HAVEN VALLEY

PUD DEVELOPMENT/PRELIMINARY PLAN

DATE: 04.30.2021
PROJECT MGR: A. BARLOW
PREPARED BY: B. ITEN

PUDSP217

OVERALL MAP

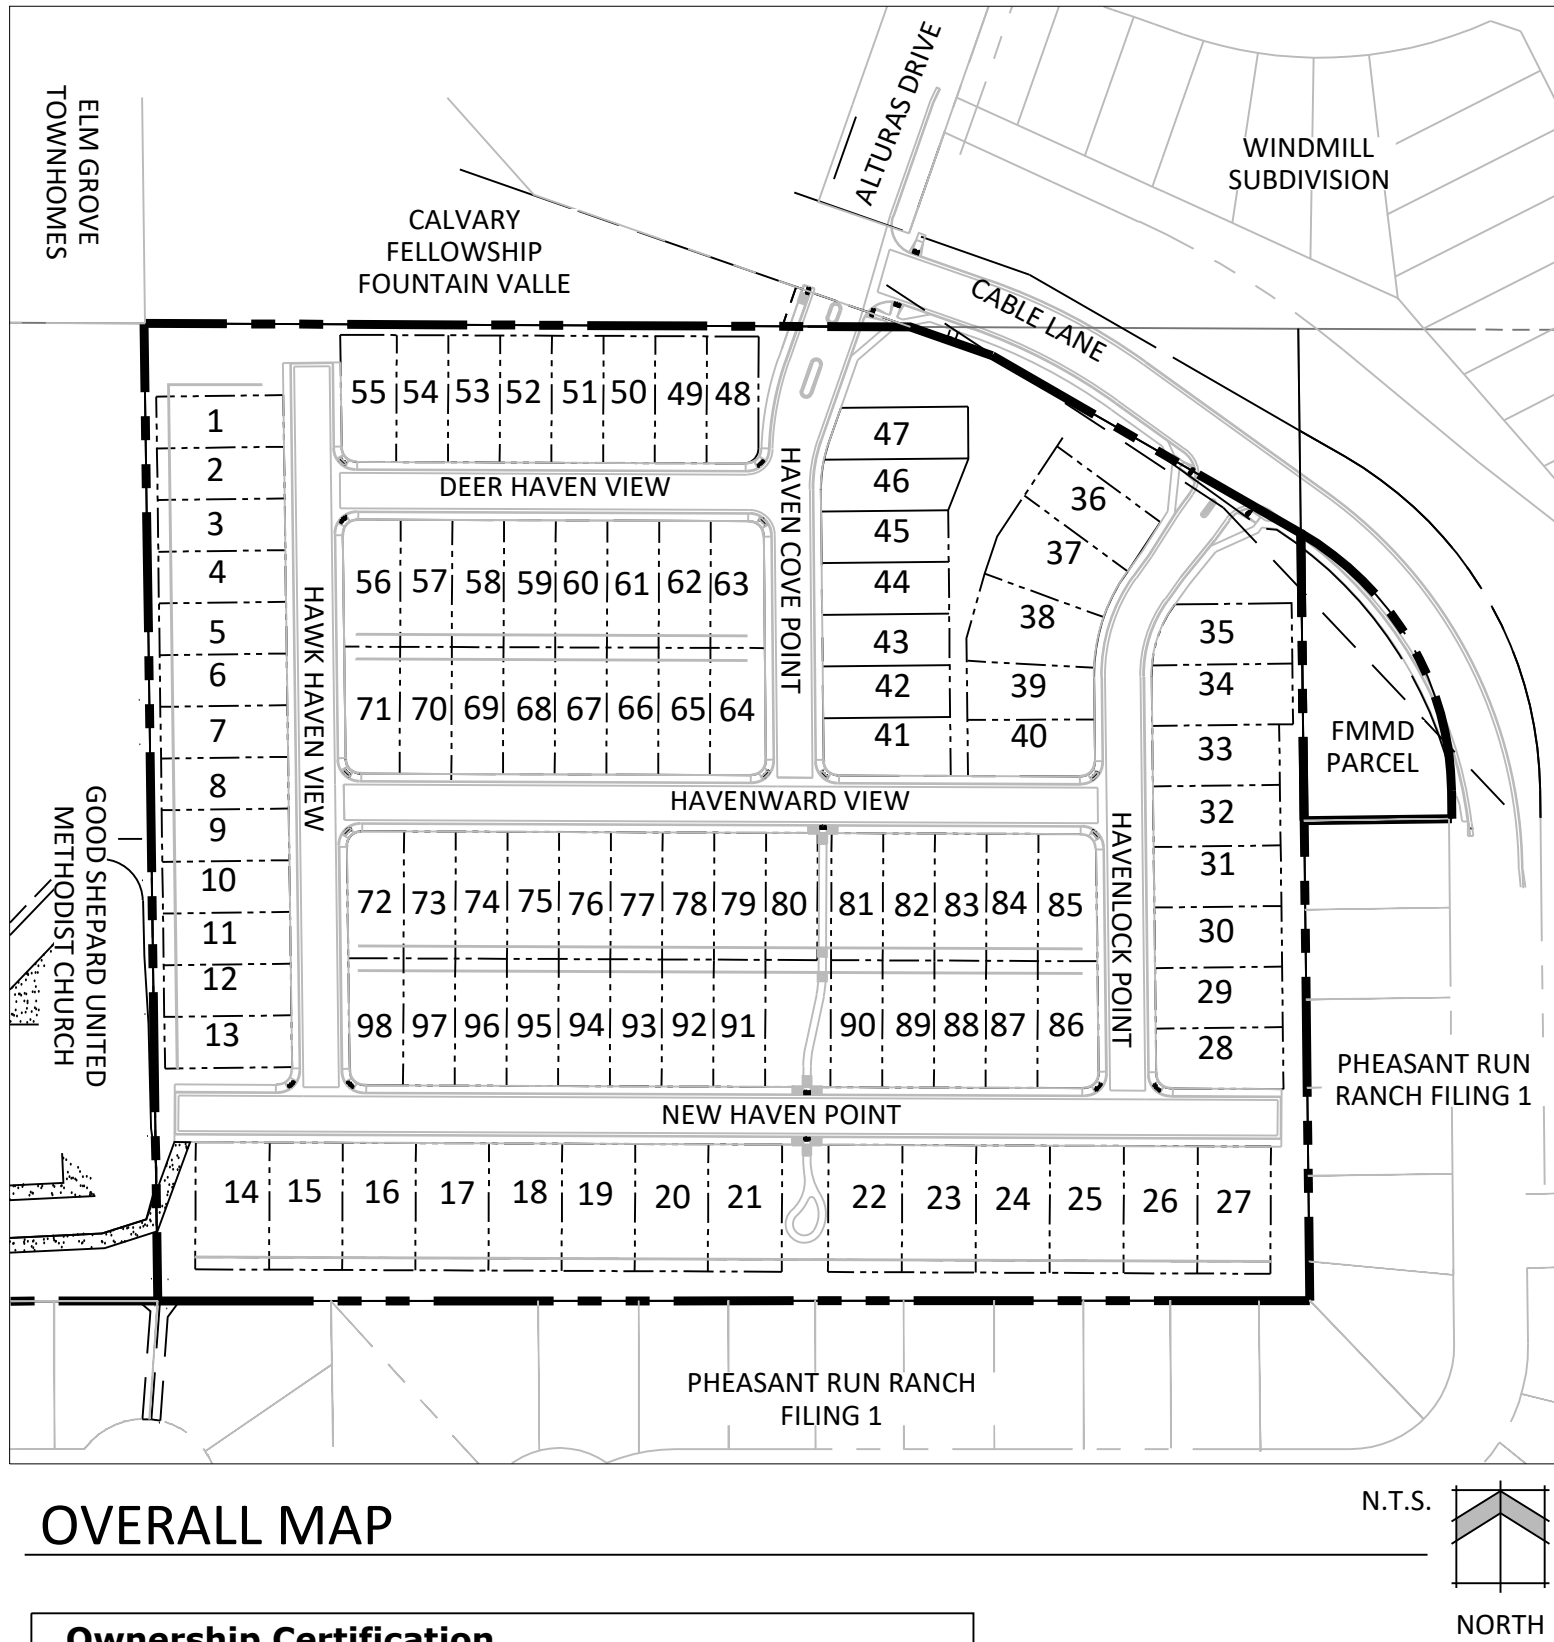
The Traffic Study identifies the internal private roadway classification as Urban Local with a 30' paved width. What is shown is a cross section for Urban Local Low Volume. Please coordinate with the traffic engineer and revise the roadway cross section and roadway layout accordingly. A comment has been provided in the TIS to identify which roadways are proposed as urban local (max ADT of 3000) and which are urban local low volume (max ADT of 300). Should deviation(s) be requested please submit the deviation form with proper justification for consideration by the ECM administrator.

TIS updated

TRACT MAP & ADJACENT PROPERTY OWNERS

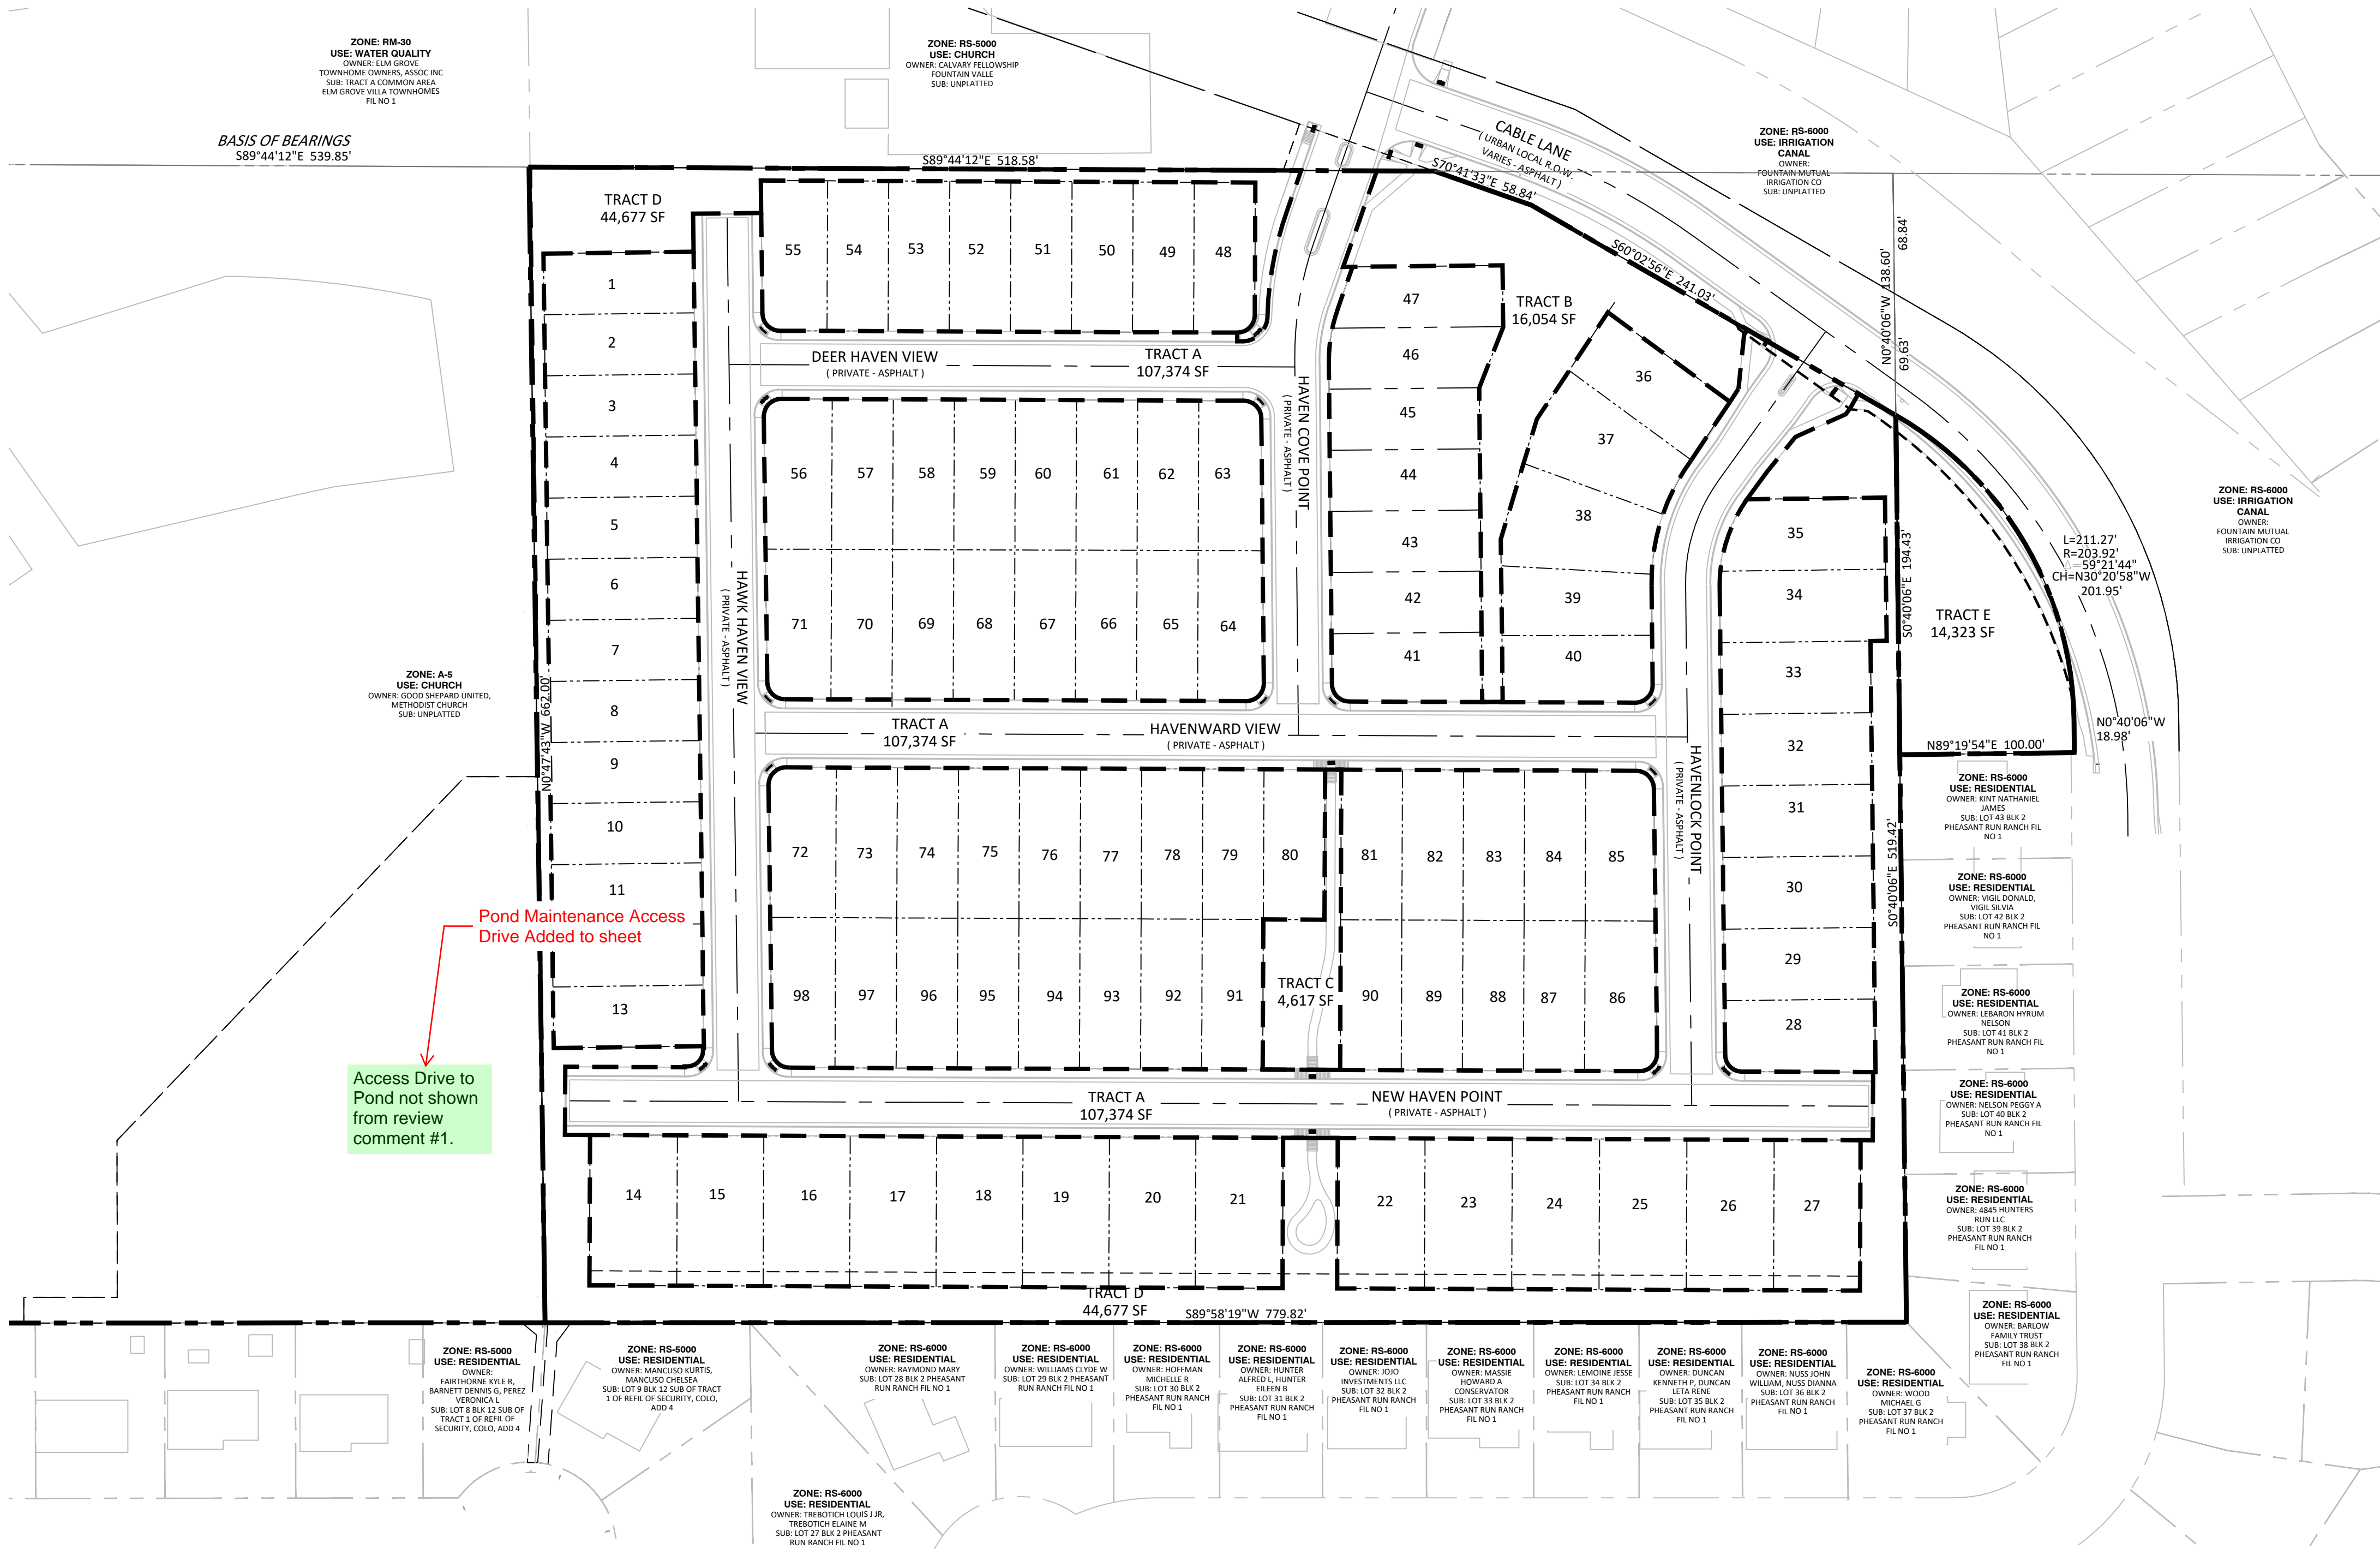
Please include drainage as a use for this tract as drainage swales are utilized in this tract to convey flow

Tract table updated. Please note tract layout/labels revised.

PRELIMINARY GRADING PLAN

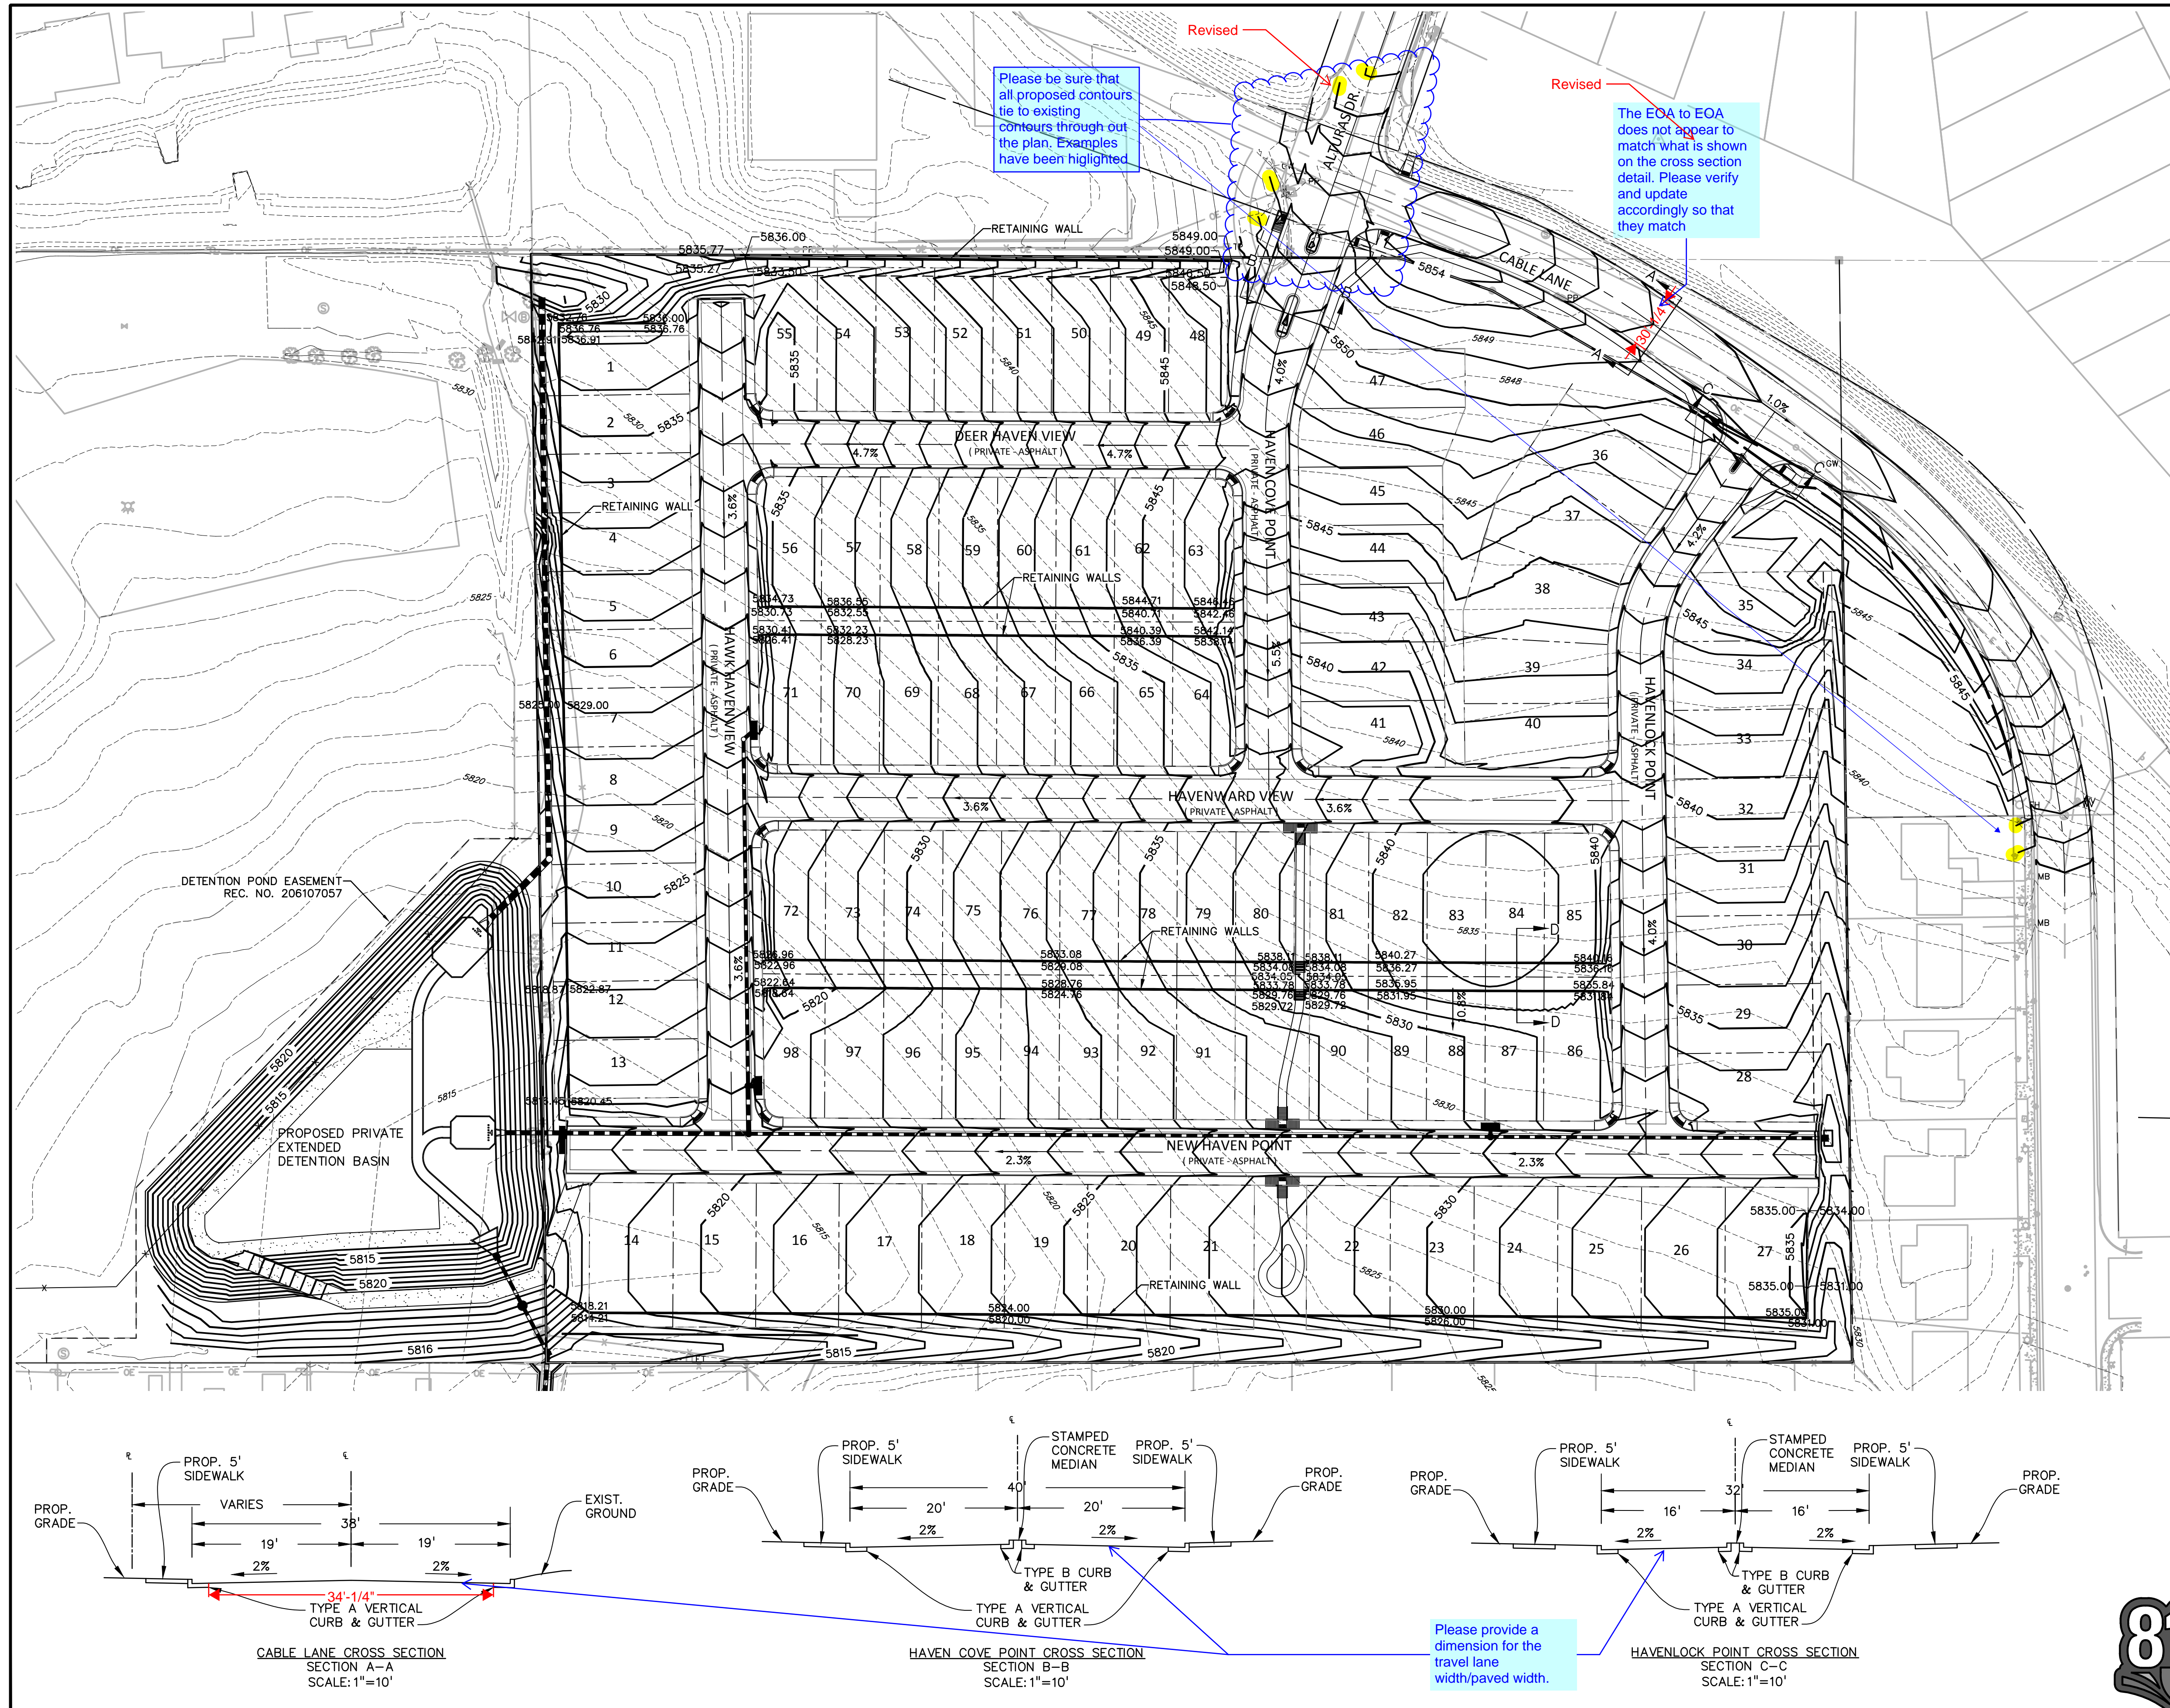
Please provide a dimension for the travel lane width/paved width.
